DISCUSSION

Bengt H. Fellenius

on “Downdrag Settlement a Single Floating Pile”

authored by W.H. Ting

Fig. 2. Load and Resistance Curves and Distribution of Settlement for the Mori Port Housing Case

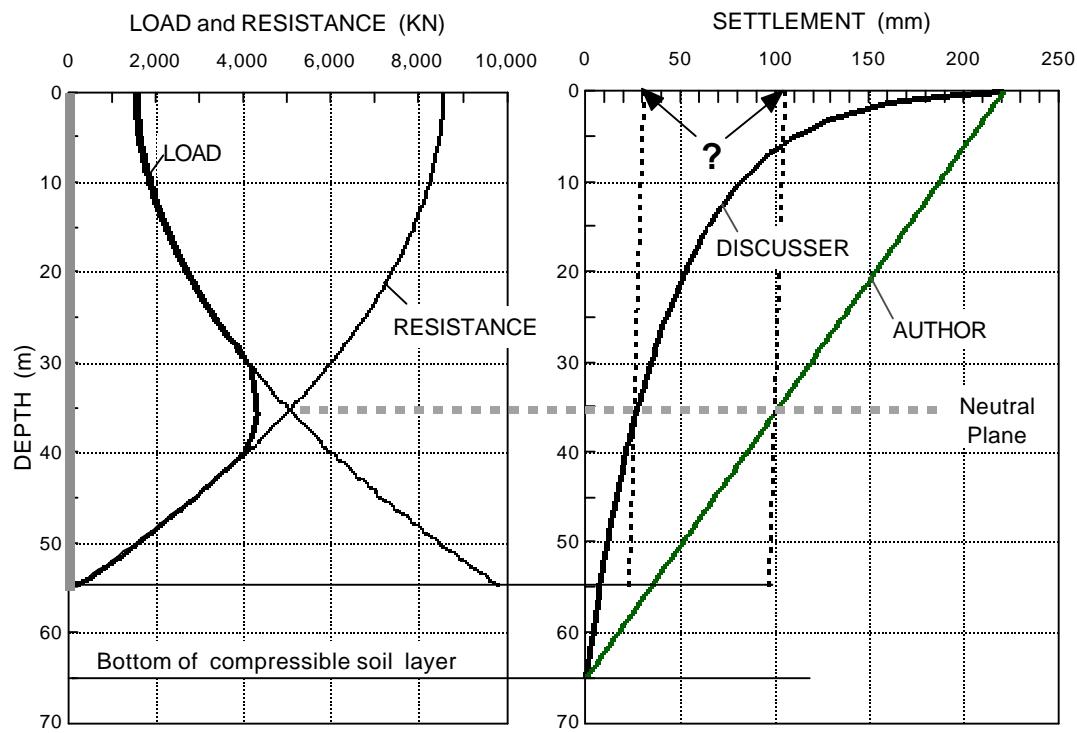
To illustrate the comments, the Discusser performed a routine effective stress analysis of the Mori Port Housing case and the results are shown in Fig. 2. The load and resistance curves are determined by the values of the static load, 1,500 KN and toe resistance, 271 KN, combined with an assumed beta-coefficient of 0.25. The diagram indicates an assumed transition from negative skin friction to positive shaft resistance between the depths of 30 m and 40 m.

The settlement calculation has been fitted to produce a 224-mm settlement at the ground surface applying a conventional analysis using the conventional approach for clay. The settlement diagram makes it clear the large difference between the linear-proportionality method of the Author and the conventional settlement analysis method.
